## Computational and Static Modeling Evaluation of CTV A1-A2 Permit Nos. R9UIC-CA6-FY21-1.1 and R9UIC-CA6-FY21-1.2

This Computational and Static Modeling Evaluation report for the proposed Carbon TerraVault 1 LLC (CTV) Elk Hills A1-A2 Class VI geologic sequestration project summarizes EPA's review of the computational modeling performed by CTV as described in the Area of Review and Corrective Action Plan (AoR CA), which is Attachment B Version 3 (submitted November 4, 2022). This report also summarizes EPA's review of the geologic narrative submitted as Attachment A Version 3 (submitted June 20, 2022) of the permit application. Clarifying questions or requests for additional information are provided below in **bold, italic** text.

**Figure 3: Cross-section across the southern San Joaquin Basin showing the lateral continuity of the major formations (Zumberge, 2005).**

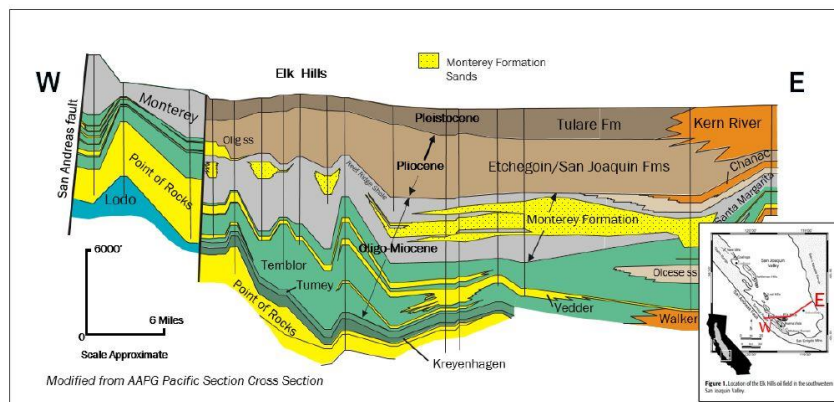
- Figure 3 in Attachment A, shown above, suggests that the Reef Ridge and Monterey Sands are time equivalent formations.
  - ***Please add a description to clarify that the Reef Ridge Formation is at the very top of the Monterey Formation.***
- Page 8 of Attachment A describes the San Joaquin Formation and Etchegoin Formation.
  - ***Is the base of the San Joaquin Formation an unconformity?***
  - It is stated that "This depleted Mya gas reservoir would effectively dissipate any possible CO<sub>2</sub> leakage before it could reach the Upper Tulare USDW". However, there is no

**Figure 11: EHOFF Showing location of NWS and 31S anticlines with 3-D seismic boundary and line of cross sections. (Right) Cross Section A-A' and B-B' showing structure of EHOFF anticlines with reverse faults.**

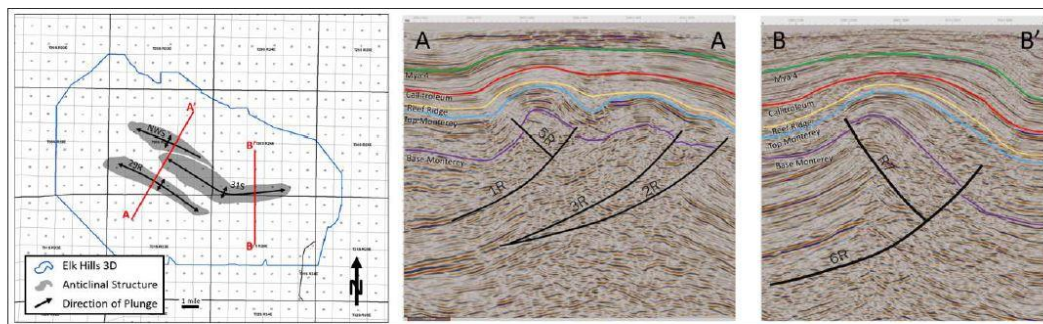
- Figure 11 in Attachment A, shown above, depicts the structure of the Elk Hills Oil Field (EHOFF) anticlines.
  - **Are there any wells that could be depicted in the cross section for reference? If so, please include the wells in the figure.**
  - **Please include a scale on the figure.**

- The A' symbol is missing from the A-A' cross section. Please indicate which side of the cross section is A'.
- Is the sharp kink in the top of the Monterey Formation in the A-A' cross section evidence of a fault? Please include reasoning as to why or why not.

Figure 14: Elk Hills oil families (Zumberge, 2005).

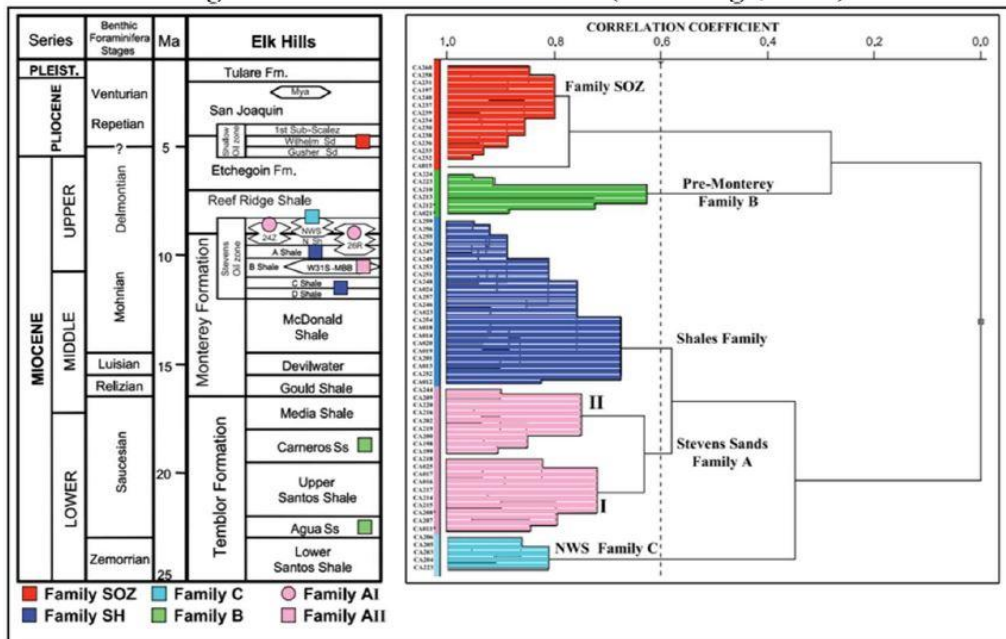
- Figure 14 in Attachment A (above) depicts the oil analysis performed in the Monterey and overlying formations.
  - Please provide the geochemical cross-plots to identify the hydrocarbon families
  - Please include a discussion on how the geochemical data compares to the pressure plots.

**Figure 19: Permeability function developed based on mercury injection capillary pressure data and calculated from log derived porosity and clay volume. Map shows the locations for wells with Monterey Formation sand core data used in the function.**

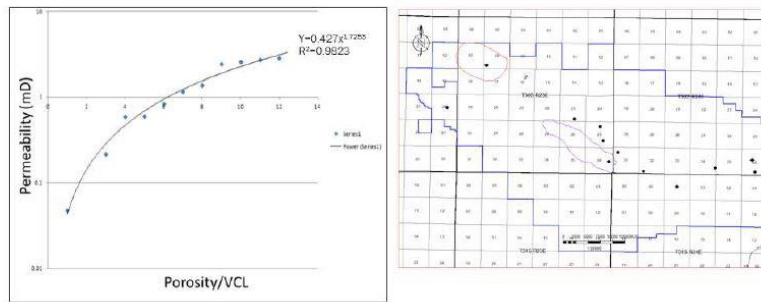
- Figure 19 in Attachment A, show above, includes a permeability curve, however there is little context, and it is difficult to interpret.
  - *Does Figure 19 show an example or subset of the total data used to derive the permeability function in the figure?*
  - *Please explain how the data in the figure relate to the permeability range of 3 mD to 1,500 mD and the average permeability of 45 mD?*
  - *What location and depths were the permeability data collected from?*

**Figure 20: Porosity and permeability for well 357-7R, showing the distribution and the input and output log curves.**

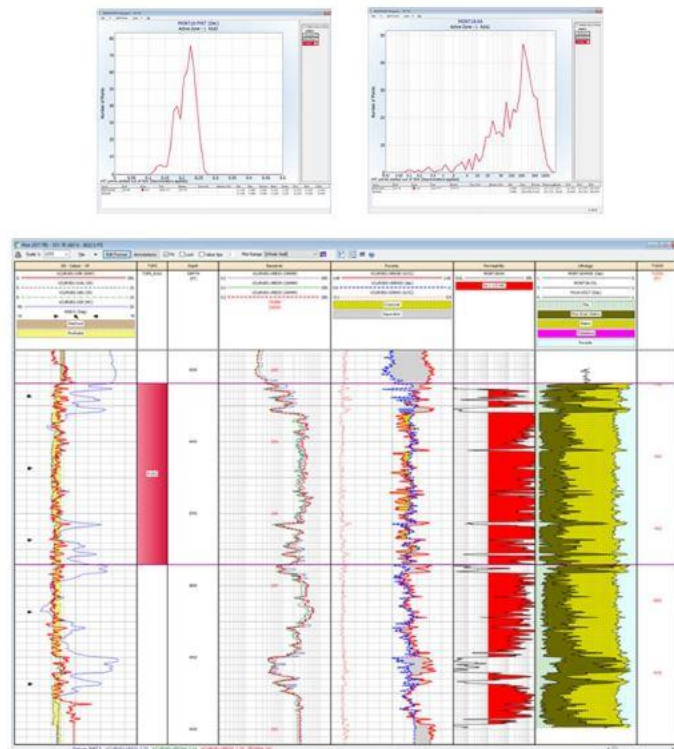
- Figure 20 in Attachment A, shown above, describes the porosity and permeability for well 357-7R. The lithology log shows no difference between the Reef Ridge Shale and the Monterey Sand.

- *Please described how the lithology log was created.*
- *Are the percentages of clay, fine grain matrix, matrix, and porosity very similar for the Monterey Formation and Reef Ridge Formation?*

- *Why does the lithology porosity percentage appear so similar between the two formations when the average porosity for the Monterey Formation is 21% and the average porosity for the Reef Ridge Formation is 7%?*

**Figure 38: Plume modeling results showing lateral confinement of the CO<sub>2</sub> plume by the edges of the anticline structure.**

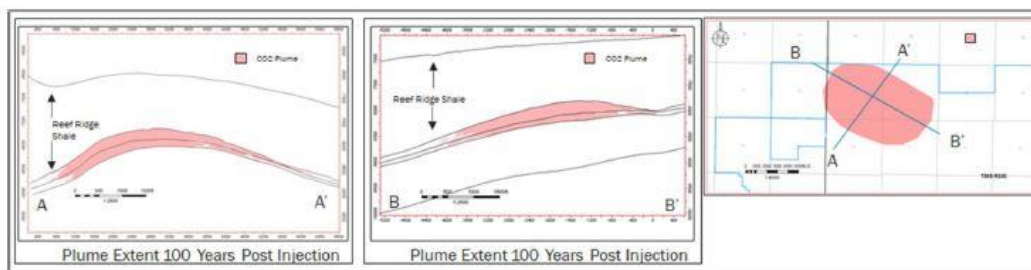
- Figure 38 in Attachment A, shown above, depicts the plume modeling results in the A1-A2 formation.

- **Please add the injectors and monitoring wells to the figure or create a new figure to help illustrate where the penetrations in the injection zone are located with respect to the predicted CO<sub>2</sub> plume modeling results.**

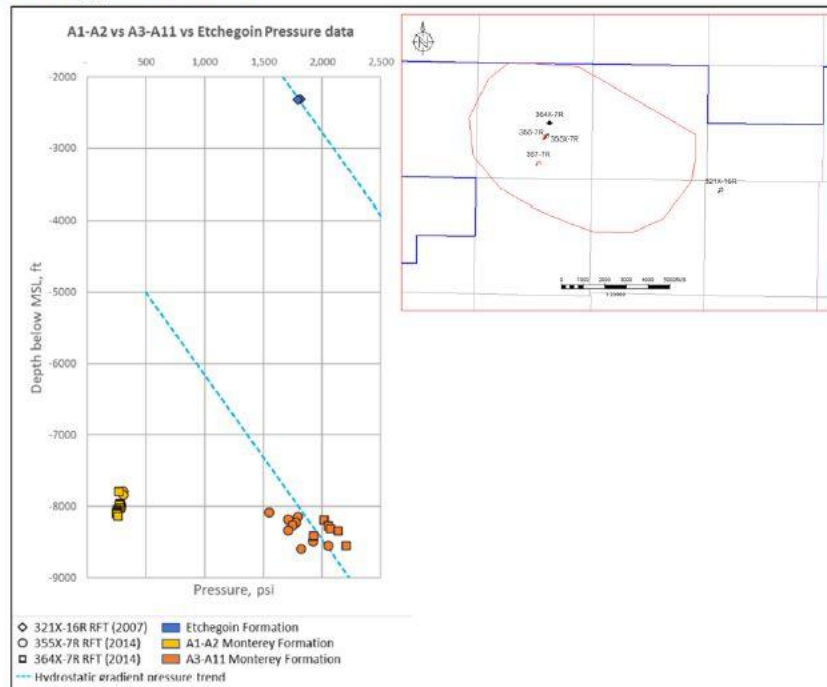
- Figure 11 in Attachment B, shown above, presents pressure data from 2007-2014 in the AoR between different formations.

- ***This data was obtained during production operations. Is there any data representative of the initial project conditions, when production has ceased, that can demonstrate pressure isolation?***

**Figure 13: Cross-sections showing the plume development through varying times through the project.**

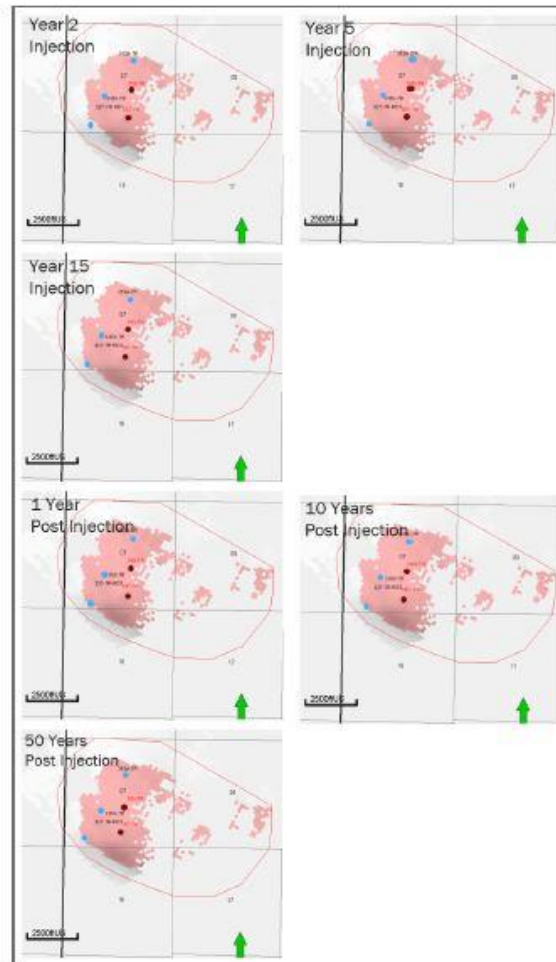
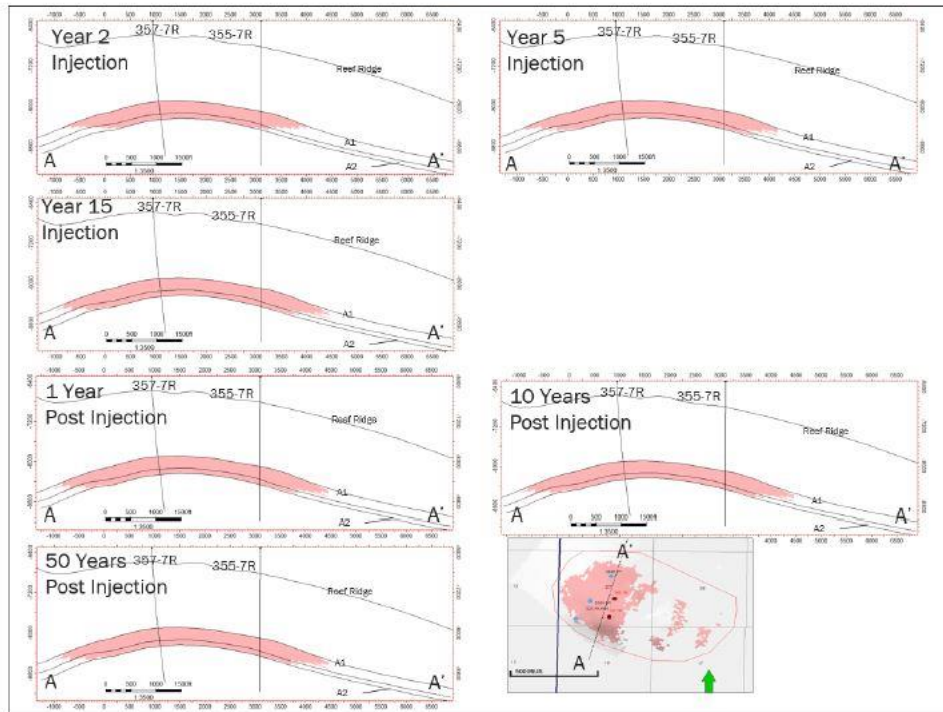
- Figures 12 and 13 in Attachment B, shown above, illustrate plume development through various times of the project.
  - ***Please display the plume results to quantitatively show the saturation. Please include cross-sectional and plan view contour plots for both gas saturation and CO<sub>2</sub> saturation at various times in the project timeframe. Please include figures of the simulated pressure plume over time, both in plan and cross-sectional views.***

- Figure 13 in Attachment B (above) depicts the CO<sub>2</sub> plume reaching the upper boundary of the model.
  - ***Please explain how the spatial extent of the model is sufficient if the CO<sub>2</sub> plume reaches the boundaries.***

- ***Please explain how no-flow boundary conditions are appropriate if the CO<sub>2</sub> plume reaches the boundaries.***
- The Model Calibration and Validation section in Attachment B describes the different sensitivities that were run.

**Figure 7: Monterey Formation A1-A2 sands porosity and permeability distribution in the static model.**

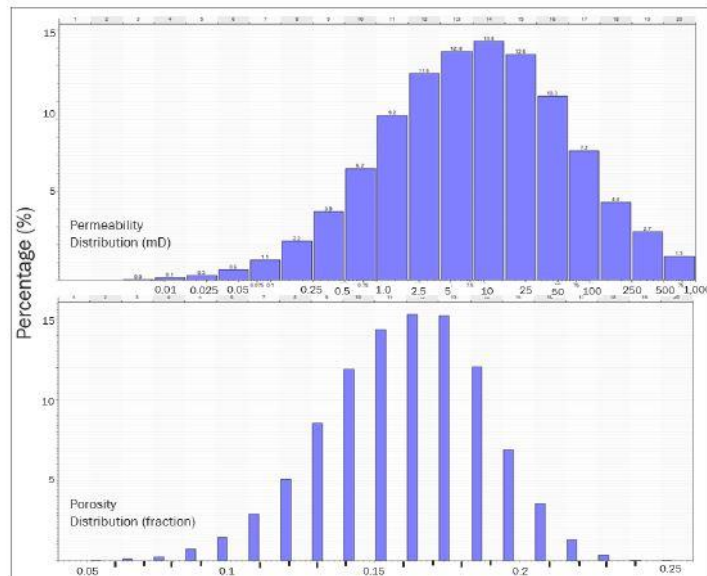
- Figure 7 in Attachment B shows porosity and permeability histograms for the Monterey Formation.
  - *Please provide additional data (open-hole well log analysis) or other measured data that can be used to verify the permeability and porosity used in the static model.*

**Figure 8: Sections through the static grid showing the distribution of porosity and permeability in the reservoir.**

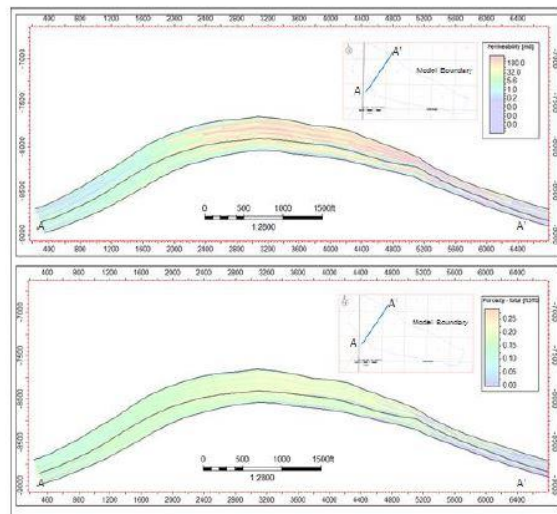
- Figure 8 in Attachment B shows the distribution of porosity and permeability of the reservoir at cross section A-A.
  - ***Additional visuals would help confirm the reservoir properties. Please provide a similar figure from a different cross section.***
- The Maps and Cross Sections of the AoR section in Attachment A mentions a “comprehensive database”, however there is not a reference to the database or any other information about it.
  - ***Please include a reference for the database described.***
  - ***Which wells submitted in Figure 5 Attachment A provide the information in the permit application? What are the sources of information?***

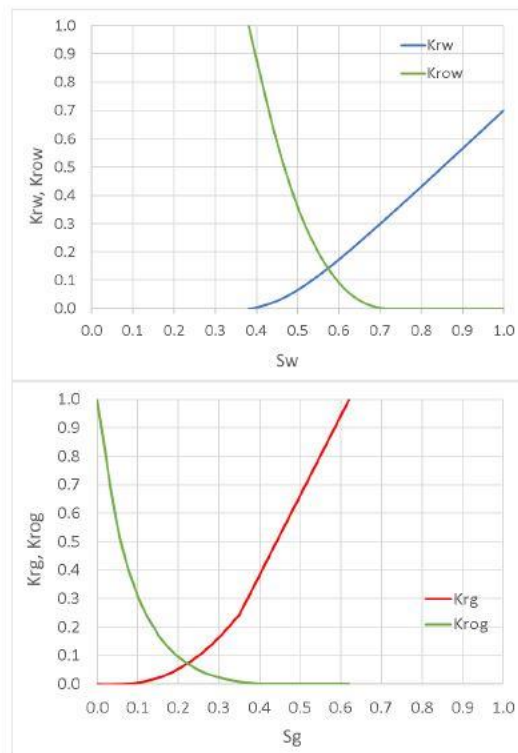
- Figure 9 in Attachment B shows the relative permeability curves used in the computational modeling.
  - ***Please provide the functional forms that were used to create the curves shown.***
  - ***Please include the data used to create the curves in a tabular form.***

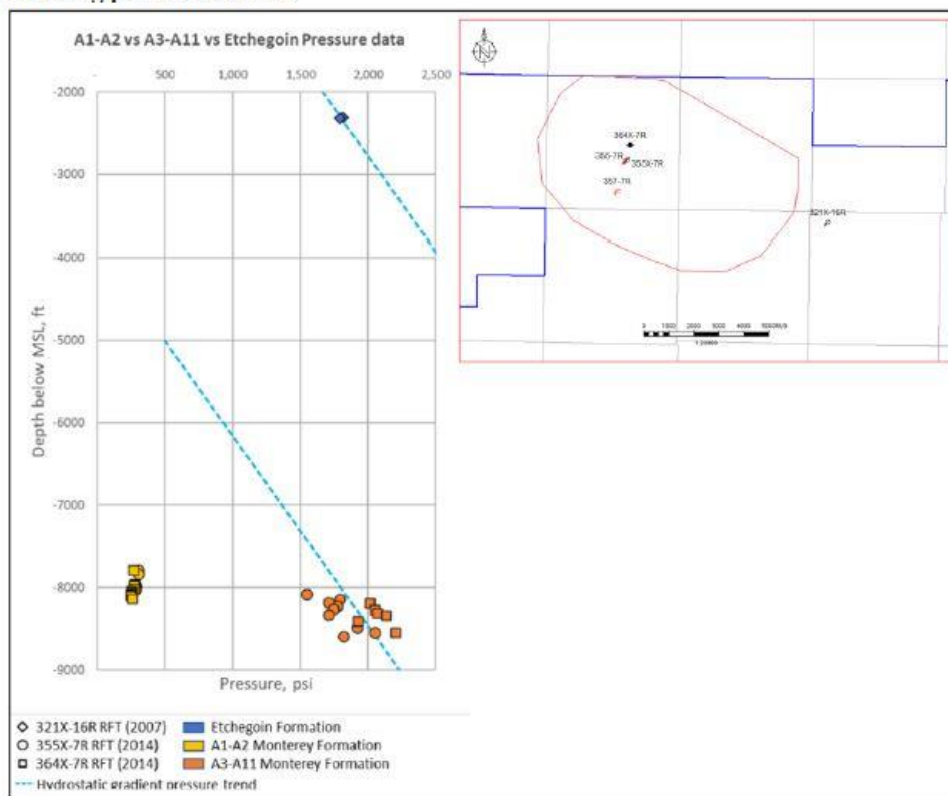
- Figure 11 in Attachment B pressure data from 2014 for the A1-A2 and A3-A11 reservoirs are shown.
  - Pressure measured at different times is needed to assure there is no migration. ***Is there any measured pressure data over different times? If so, please provide it.***

- Pressure in the Etchegoin Formation and A3-A11 reservoir is the same even though the y-axis shows their depth is very different. ***Please provide an explanation. If production from the A3-A11 reservoir resulted in pressure depletion, please include that in the explanation.***
